## REPORT FOR ACTION

# Demolition of Three Heritage Properties in the South Rosedale Heritage Conservation District - 5, 7, and 9 Dale Avenue - Supplementary Report

Date: July 25, 2018  
To: City Council  
From: Chief Planner and Executive Director, City Planning  
Wards: Ward 27 – Toronto Centre-Rosedale

Attachment 2: Revised Proposal - Site Plan with Modifications Highlighted

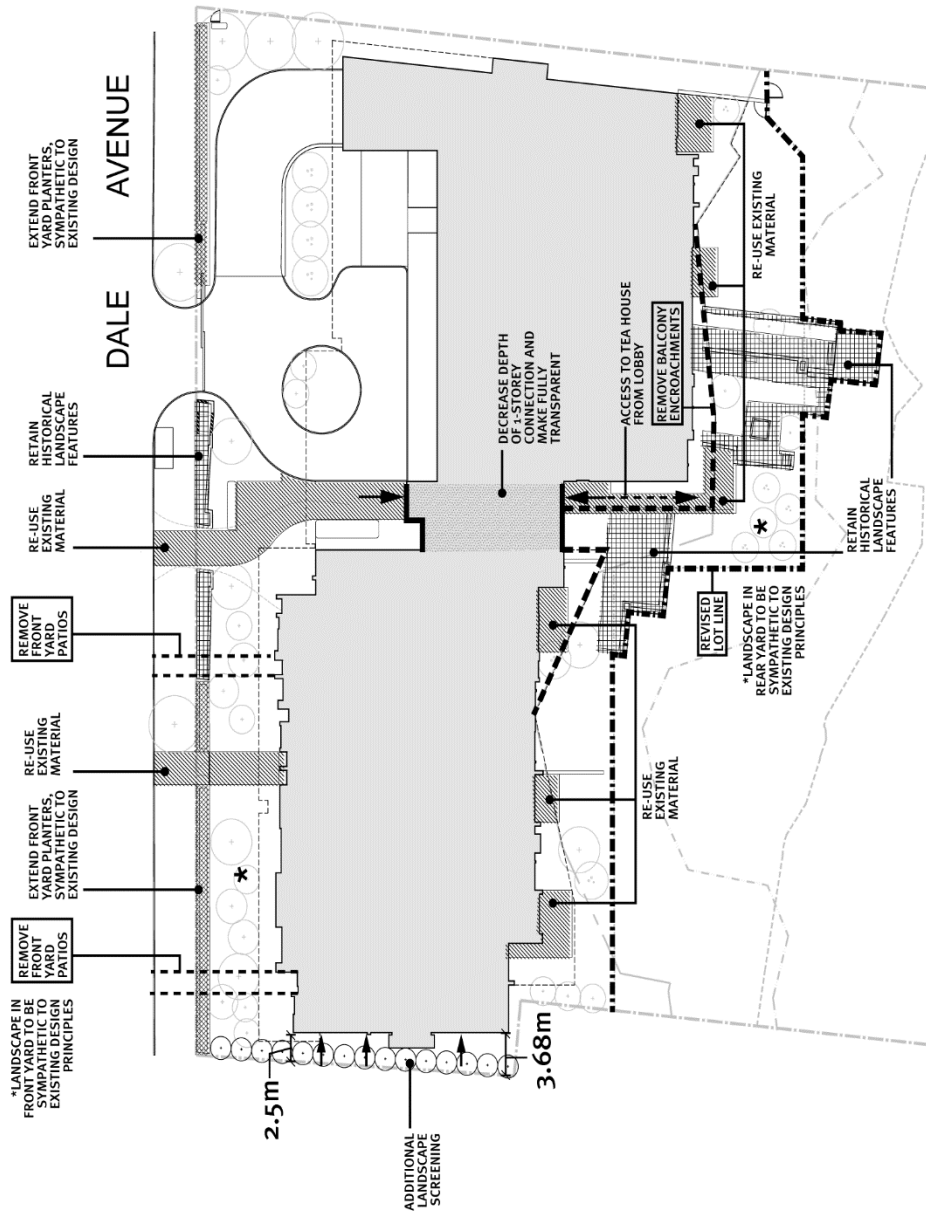
In this instance, HPS Planning staff found that the original proposal did not sufficiently conserve the heritage attributes found in Section 4.2.2 "Streetscape Heritage Character" of the Study and was therefore neither equally or more able to contribute to the heritage character of the district. For example, the replacement building would have significant visual impact on the landscape setting when viewed from the street and it would negatively affect the HCD's park-like setting.

- Increasing the west side yard setback for the front portion of the building to a minimum of 2.5 metres to allow sufficient space for 6 inch caliper, 25 foot tall beech trees to be planted along the west side wall;

- Continuing the west side yard beech trees into the front yard to further screen the building from the public realm;
- Removing balcony encroachments into the 3.6-metre gap between the two halves of the building to increase visual permeability into the ravine; and

- Decreasing the depth of the 1-storey portion of the building connecting the two halves of the building and making the north and south walls fully transparent to further enhance the visual permeability into the ravine.

As requested by Toronto and East York Community Council, Planning staff met with the applicant and discussed the abovementioned concerns. The applicant responded with a with prejudice settlement offer (July 20, 2018) that incorporates the following revisions:

- Retaining the "tea house", planting beds and garden walls, and as much of the historic landscape and landscaping features as possible in the rear yard of 7 Dale Avenue to be used as a common outdoor amenity space, subject to the approval of TRCA and RNFP staff. Planning staff have begun discussions with the TRCA regarding these modifications;
- Retaining as much of the historic landscape and landscaping features at the front of the property as possible, such as the front yard boundary wall-planter, iron railings and gates;
- Extending the front yard planters in a form that does not replicate but responds sympathetically to the existing planters;
- Removing front yard outdoor patios and two pedestrian walkways to increase the amount of soft yard landscaping;

- Landscaping the new front and rear yards in a form that is sympathetic to the design principles of the existing landscaping;
- Reusing existing paving materials for the front entrance walkway, the emergency walkway from the west half of the building, and rear terraces;
